MEMORANDUM

To: Mr. Scott R. Elmer, P.E.
From: Kevin T. Vogel, P.E., CFM
Craig T. Maske, P.E., CFM
Project: Steady Flow Analysis of Vicksburg Ditch

Re: Kitty Hollow Lake Model

Figure 1: Vicksburg Ditch Profile Comparison

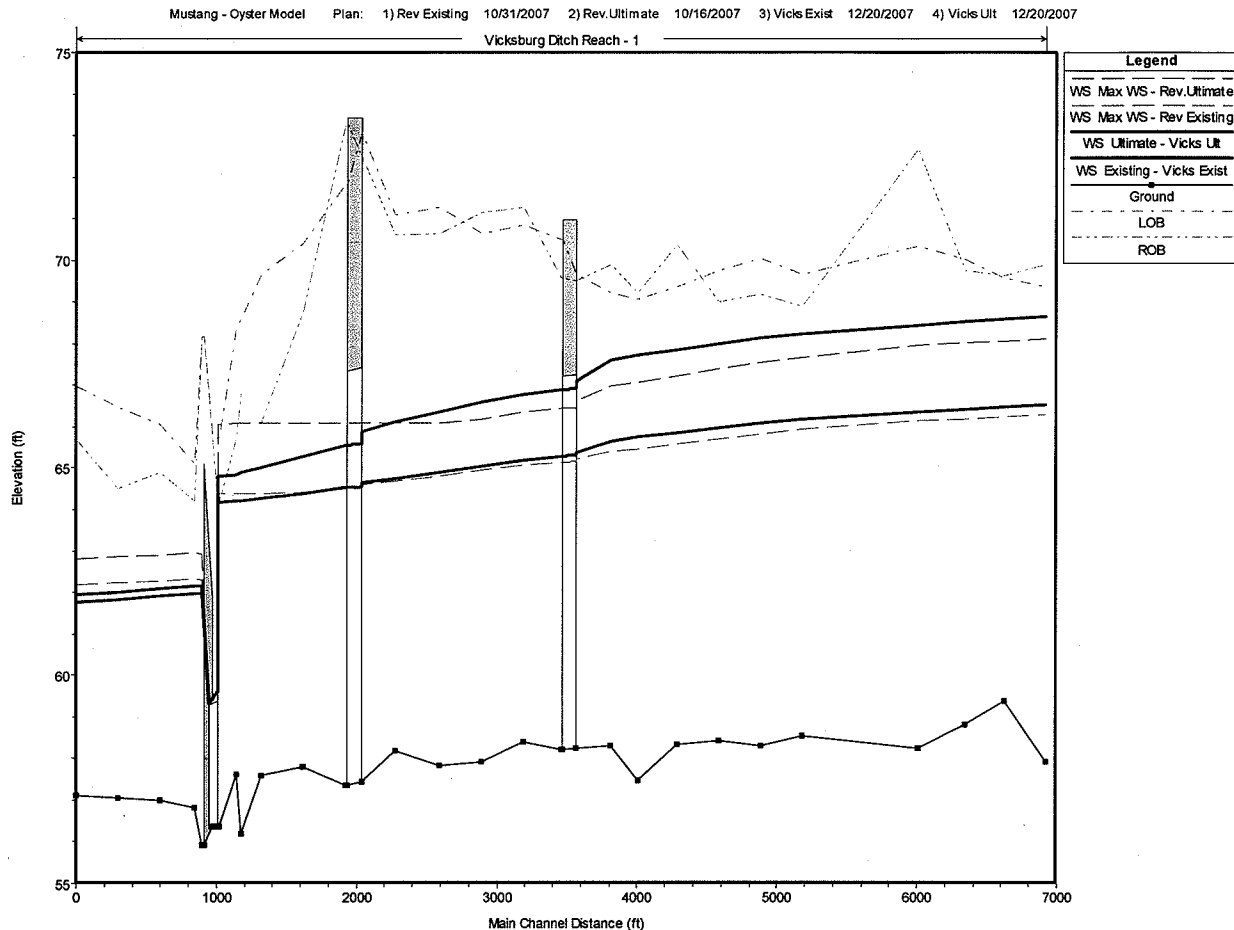
In the meeting, we requested the models for review and received them on November 1, 2007. Our review of the models for Kitty Hollow Lake and the adjacent watercourses found that the analysis appears to adequately represent the interaction of Kitty Hollow Lake and its adjacent watercourses and in particular the Vicksburg ditch. The only additional item we are requesting is that a steady state analysis be completed on the Vicksburg ditch to allow a direct comparison to the previous models for Vicksburg.

The results of the steady flow hydraulic analysis are attached to this memorandum and summarize computed water surface elevations for each channel cross-section within the model. Figure 1 below provides a stream profile comparison of the Vicksburg Ditch. Stream profiles for the existing and ultimate developed conditions are shown for both the steady flow and unsteady flow analysis. The computed water surface profile from the steady flow analysis produces slightly higher water surface elevations for portions of Vicksburg ditch starting just upstream of Lake Shore Harbor and extending to the most upstream cross-section. The maximum increase in water surface elevation was 0.28 feet for existing conditions, and 0.67 feet for ultimate conditions. For the portion of Vicksburg ditch between the culvert-weir control structure and Lake Shore Harbor, the steady flow analysis produced lower water surface elevations than the unsteady model. The reason for this decrease is because the maximum water surface elevations computed in the unsteady analysis for this portion of Vicksburg ditch are controlled by maximum water surface elevations within Kitty Hollow Lake and not peak runoff rates within the stream's watershed.

Figure 2: Vicksburg Ditch Profile Comparison – Normal Depth vs. Kitty Hollow Peak Starting Tail-water Conditions

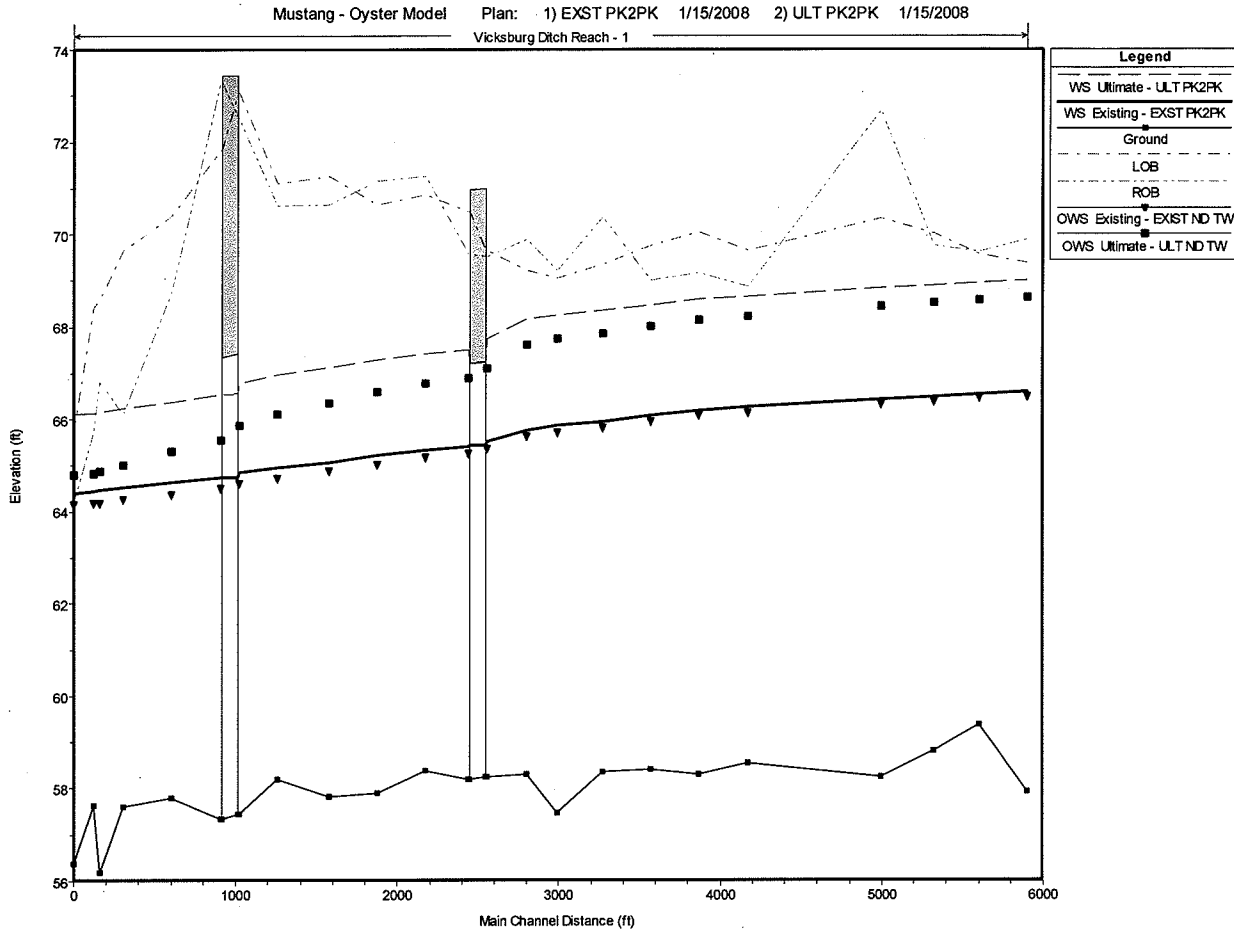
A request to consider a “peak on peak” event for the Vicksburg Ditch was also made by FBC MUD 47. The MUD requested that the steady flow model of Vicksburg Ditch be started at the Kitty Hollow Lake diversion weir assuming that the lake was at its (1%) maximum water surface elevation. This event would be considered highly unlikely because the peaks in Vicksburg Ditch and in Kitty Hollow Lake are approximately 9 to 9.5 hours apart in the design storm event, and, rather than representing a peak-on-peak event, would more appropriately represent two 1% storms occurring back-to-back (another 1% rainfall occurring while Kitty Hollow Lake was still at its maximum water surface), which is an event with a much lower frequency than a 1% annual chance.

Regardless of the likelihood of the event, a model was created in order to show this condition. In order to create the model, the ditch sections downstream of the weir were removed from the model so that the downstream end of the ditch began at the weir. Existing and Ultimate Conditions 1% water surface elevations are shown in the figure below and are compared with the original steady flow profiles. As noted in Figure 2 below, the peak water surface elevations are approximately 0.4 feet higher at the upstream end but remain below the identified bank elevations. Information comparing these elevations in the separate plans is attached to this memorandum.
